1 CPTED SITE PLAN
3/32" = 1'-0"

PROPOSED WAREHOUSE FOR:

REGANZANI GROUP LLC

.SP 1.3

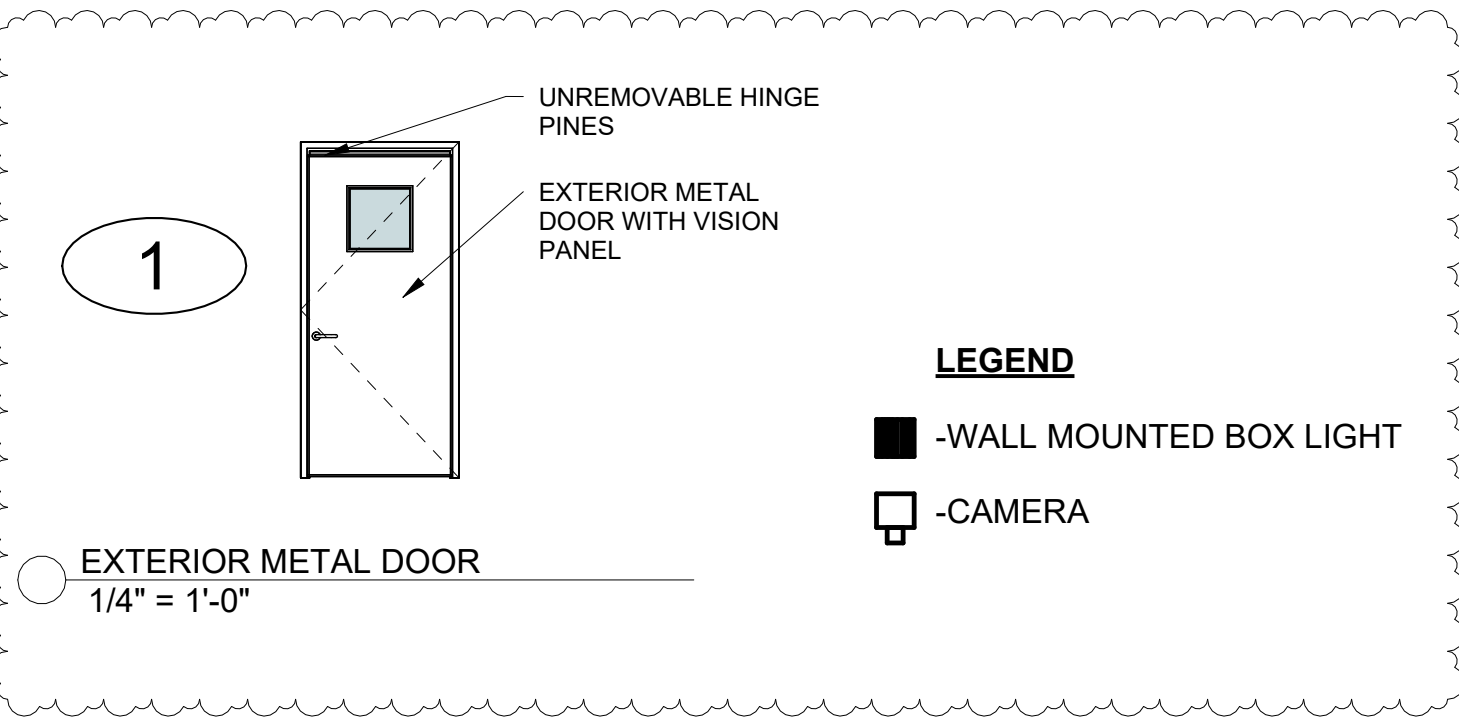
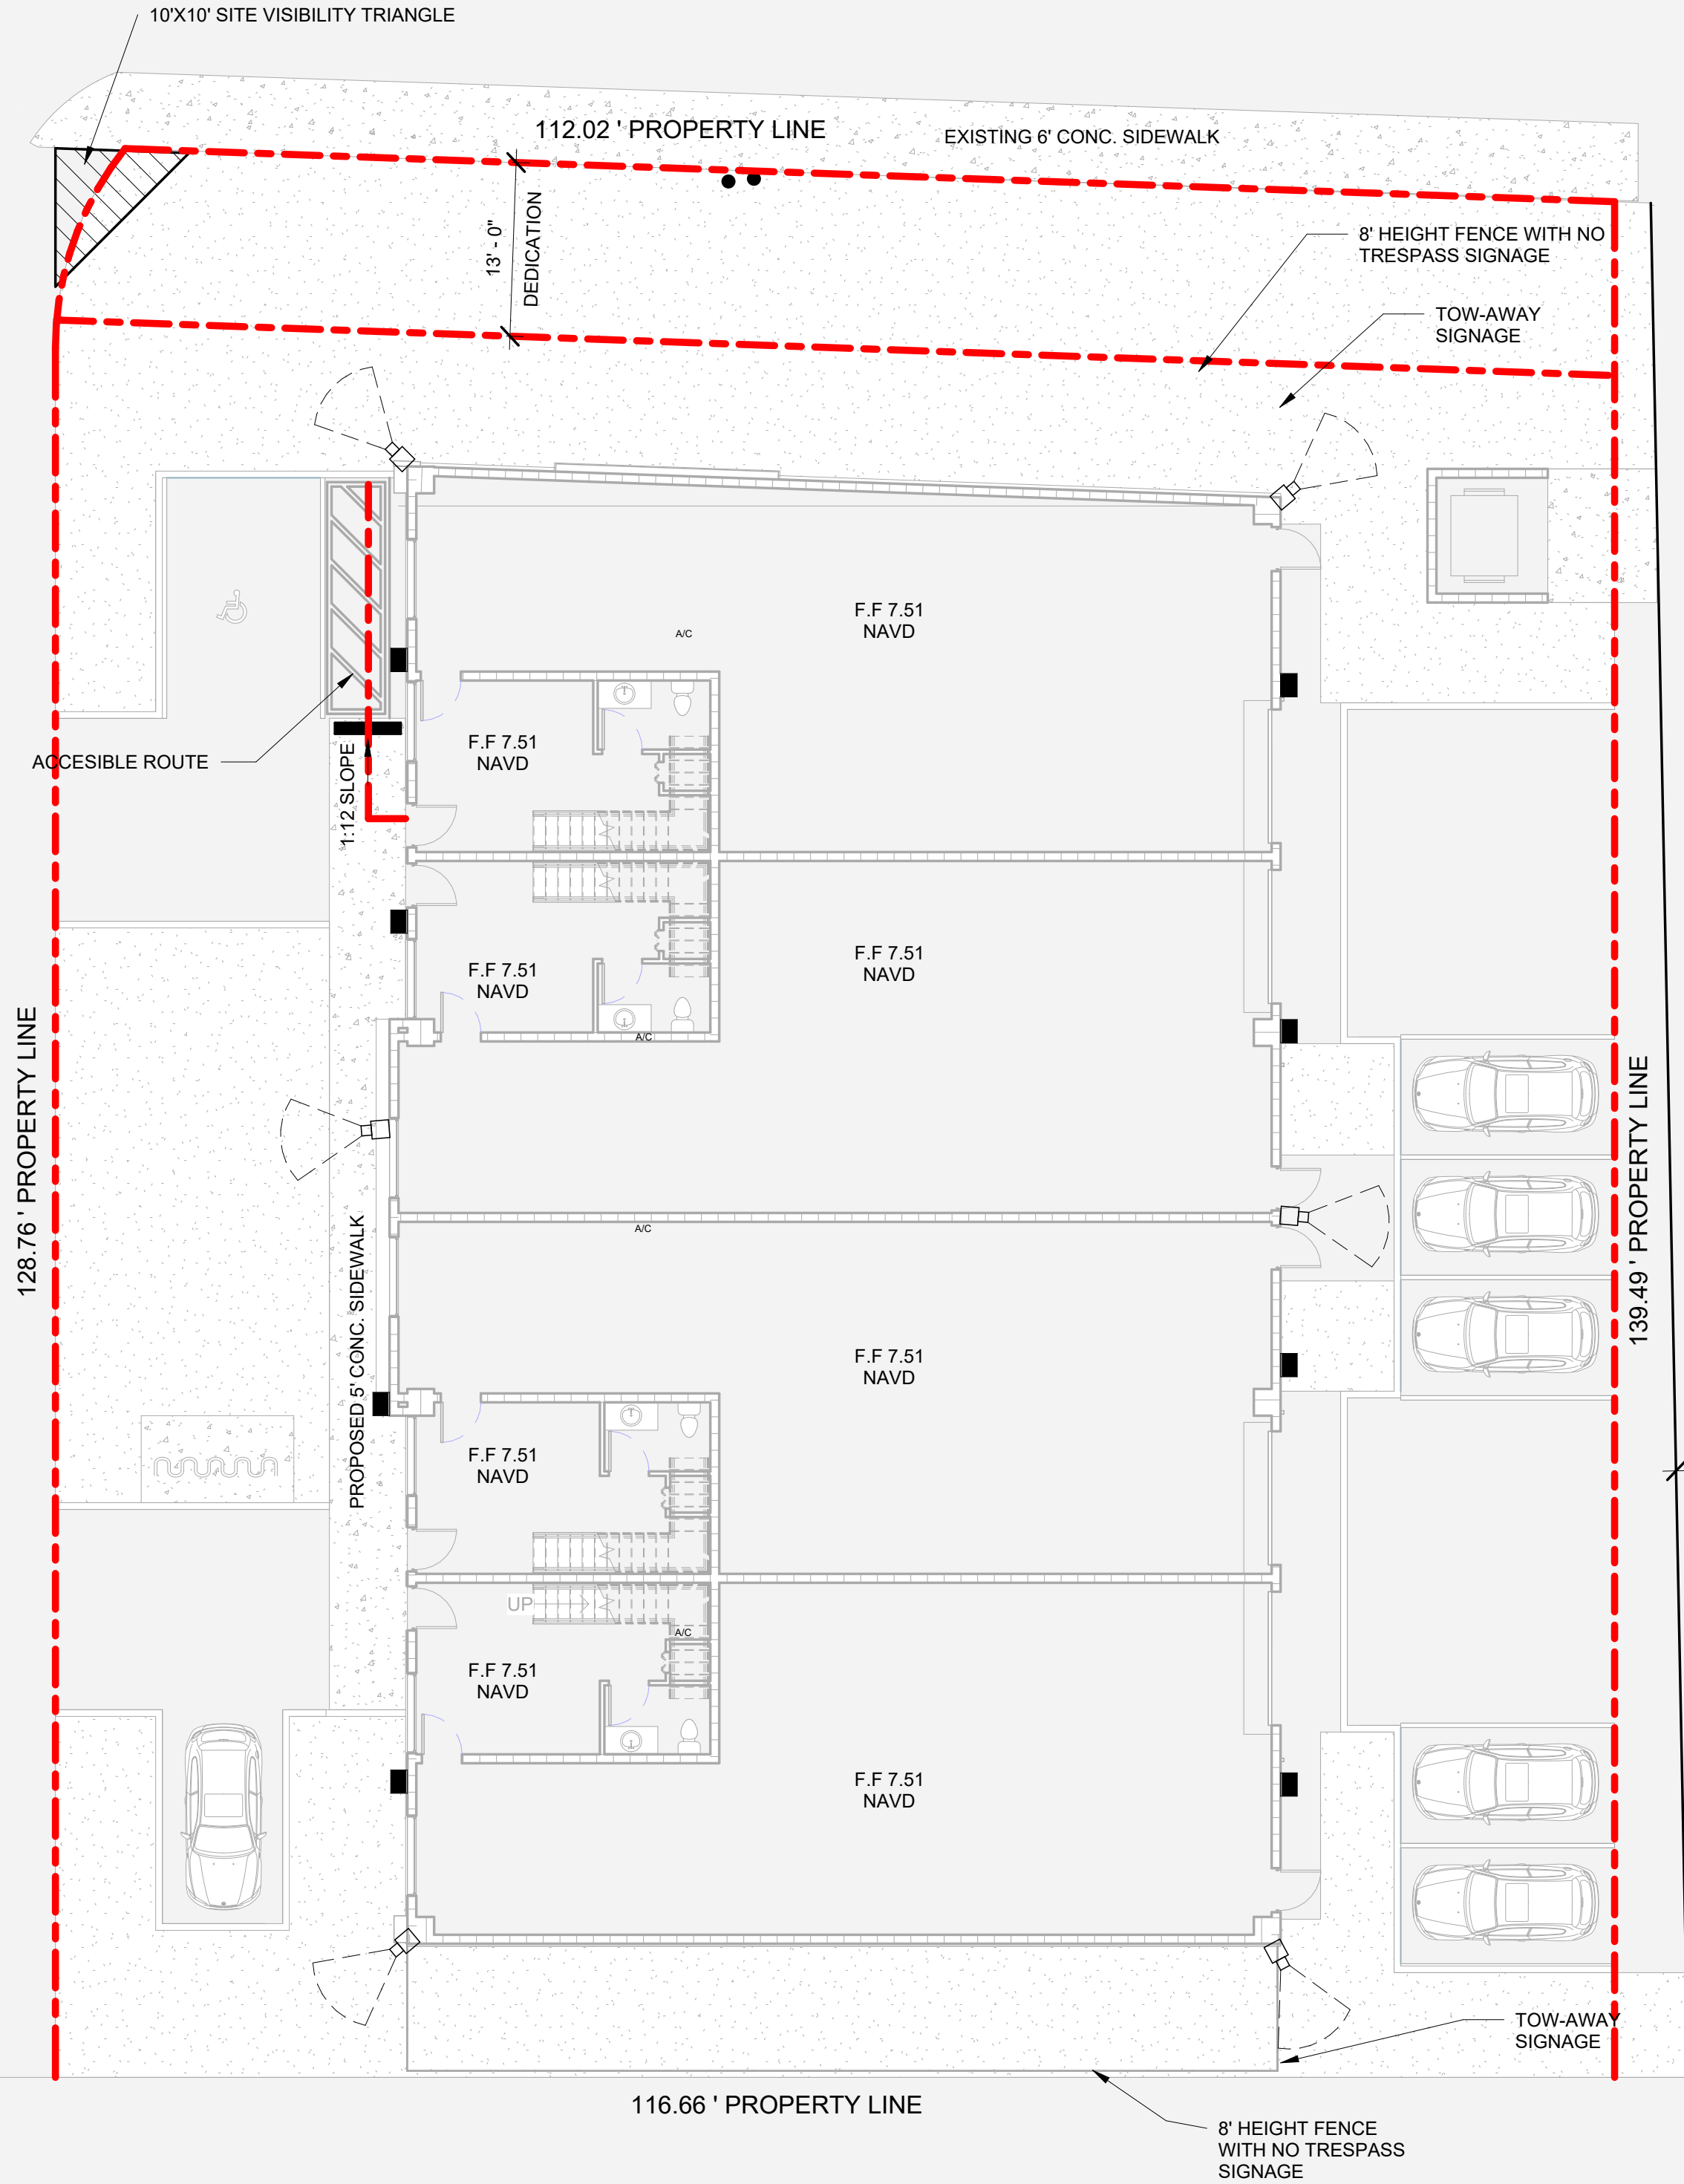
- A. Natural Surveillance (Landscaping)
1. Tree canopies should not be lower than 8ft in height. (Note that young immature trees with 6" inch or less diameter trunks are excluded from this condition ONLY WHILE MATURING per code.)
1. Designated ADA access ramps (if any) are to utilize see through fence railing for improved natural surveillance.

Will Comply
1.) Surveillance Monitors depicting real time security camera views must be strategically located for maximum overlapping active and passive observation.

- 1.) Install hard-wired burglar security alarms, or at the minimum prewire each unassigned / vacant warehouse bay.
- Will Comply**
2.) Perimeter Fencing
(Please clarify: The CPTED Narrative states 6' high fencing around the building & the CPTED Diagram states 8' fence indicated at the north & south side of the building. If the fence goes completely around the building, please describe the access control method i.e., manual, electronic, rolling or swing gates, etc.)

- 1.). A robust locking mechanism such as a throw bolt with a robust shielded padlock for example rather than only a vulnerable chain and non-shielded padlock.

- 2.) Bottom gate clearances must be 8" above the ground. Purpose: For viewing underneath to deter loitering and trespassing inside the enclosures, and to deter/ prevent the enclosure from being used as concealment/ ambush for a more serious crime such as a violent robbery, sexual assault/ battery, etc.

- 3.) If there is a pedestrian passageway into the dumpster enclosure it must have the lockable gate which remains closed and locked except when in active use by authorized persons.

- 4.) Enclosed trash rooms (if any) must be equipped with either constant lighting &/or a secured motion sensor lighting system that will provide immediate illumination upon entry.

1. Submit a Broward Sheriff's Office No Trespass Program Affidavit.
- Will Comply**
2. Post sufficient "Broward Sheriff's Office No Trespass" signage so that it is readily available at all entrances and all sides of the property: North, South, East, and West. Please note additional signage may be necessary depending on the size & layout of your development.

3. Post BSO No Trespass signs prominently with bottom edge of sign at approximately a minimum of 6' to 7' feet inheight from ground level for clear unobstructed viewing throughout property and from the site perimeter lines. Secure robustly using sturdy fasteners at all corners to help prevent vandalism.

1. Exterior wall surfaces along the building perimeter must be treated with a graffiti resistant resin up to 8 feet to prevent vandalism.

2. All publicly accessible exterior electrical power outlets must have a lockable metal cover AND easily accessible secure internal cutoff switch.

3. All publicly accessible exterior water outlet spigots must have a nearby easily accessible secure locking cap.

4. Security / Convex mirrors must be incorporated into areas with limited visibility that are not covered by security surveillance cameras & considered to be potential points of concealment, ambush &/or extreme safety concern.

5. Any exterior storage tanks utilized for keeping contents under pressure and / or containing any flammable or hazardous contents must be properly secured against any acts of vandalism, theft, or misuse of any kind. Only use fire code approved security systems / mechanisms.

6. The number address signage must be unobstructed by landscaping or external features, provide good color contrast, be visible from the roadway & preferably be reflective for instant recognition by law enforcement & EMS when responding to emergency calls for service.

- 1.) Place bike storage racks (if any) close to the main access doors providing convenience and maximum Natural and Electronic Security Surveillance.

- 2.) If the building/ development has a Wi-Fi system, it needs to be encrypted, and password protected. If Wi-Fi is offered as a complimentary service by a business, then it should be disabled when the business is closed to the public.

- 3.) Exterior bench seating (if any) for public use should be CPTED orientated to include spacers / dividers / arm rests or preferably use a single seat design.

- Will Comply**
B. Access Control - Security Strengthening

Will Comply

Will Comply

Will Comply

Will Comply

Will Comply

Will Comply

Will Comply

Will Comply

Will Comply

Will Comply

Will Comply

Will Comply

Will Comply

Will Comply
